Improvements (changes) of Switch Assem

How to Change the Chiller Switch Assembly

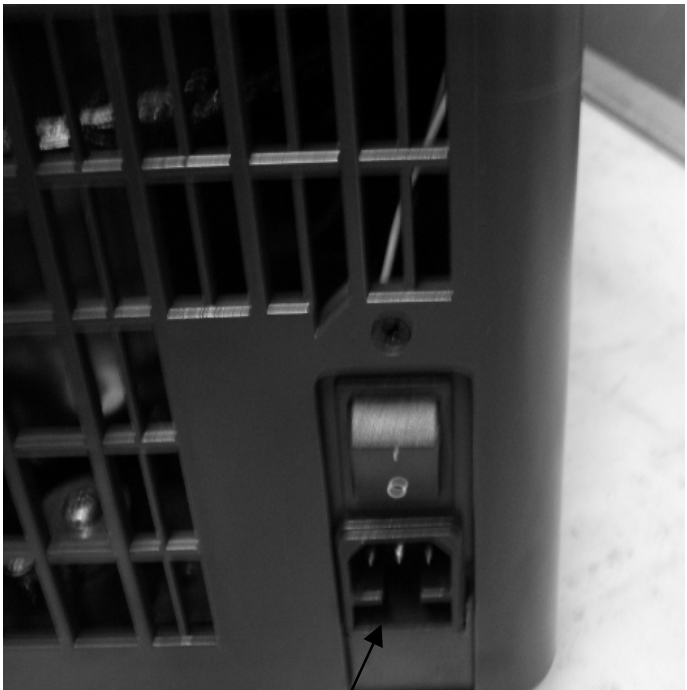
EXISTING

Fuse 250V 10A (Use 1/10,1/5HP)
Fuse 250V 16A (Use 1/4,1/3HP)

IMPROVEMENT

Fuse 250V 10A (Use 1/10,1/5HP)
Fuse 250V 15A (Use 1/4,1/3HP)
